CHANGES TO THE DRAWING:

Replacement Sheet
Title: LOUDSPEAKER DRIVER
Inventor(s): Andreas BUOS et al.
Appl. No.: 09/986,115

Fig 3

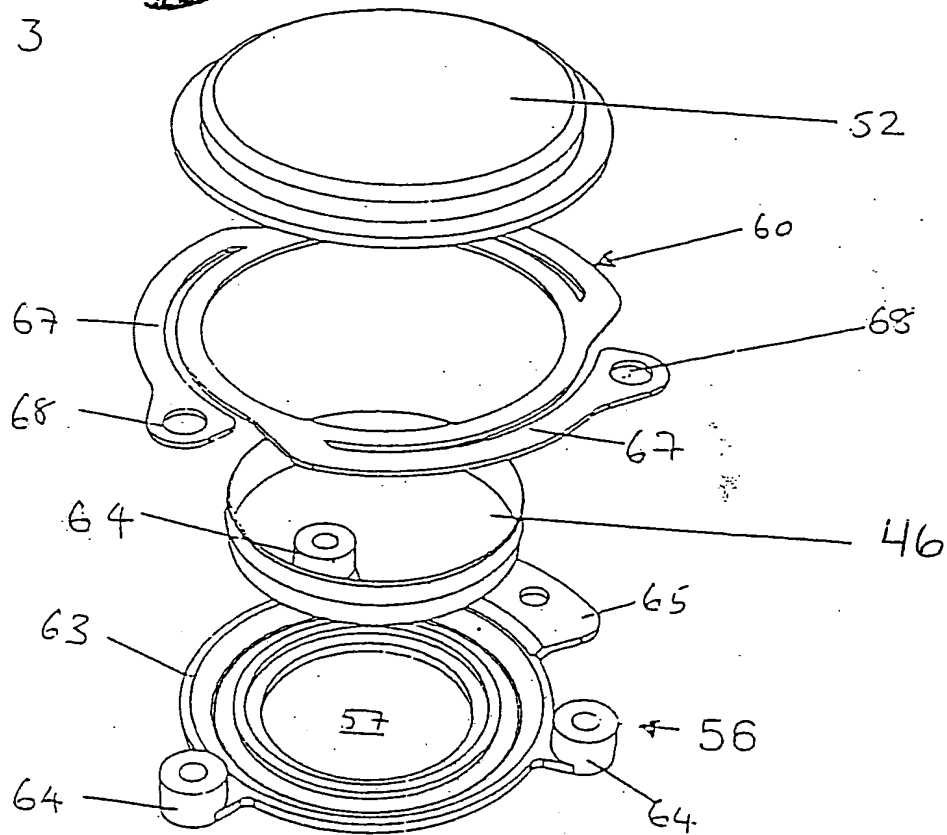
Fig. 3 has been amended to replace the erroneous reference number "76" with the correct reference number "46."
